## 3 DOWNSHIRE HILL LONDON NW3

In response to the point raised in your email of the 4 June please find our comments

FIGURE 11

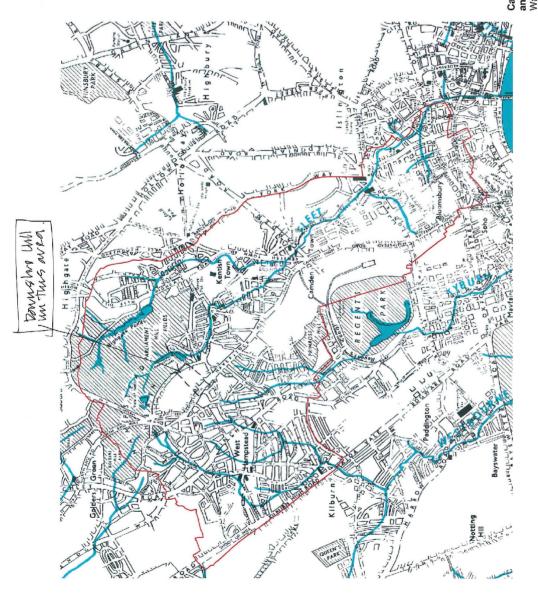
- Attached is a Map that is supplied by Camden showing the water courses in the area. It can be seen
  that there are no recorded water courses along either Pilgrims Lane or Downshire Hill. The main water
  courses are either side of the Haverstock Hill and will generally be fed by surface run off.
- I can see no mention of a well under No 8 Pilgrims Lane, however one of the maps within the BIA notes
  there are two bore holes within 100m or so. These are marked as 'W' but are water extracting bore
  holes that are over 140m deep and extend in the chalk aquifer. Our basement will not have detrimental
  effect on the bore holes.
- 3 The additional tests for the permeability exercise are within appendix 6 of our report.
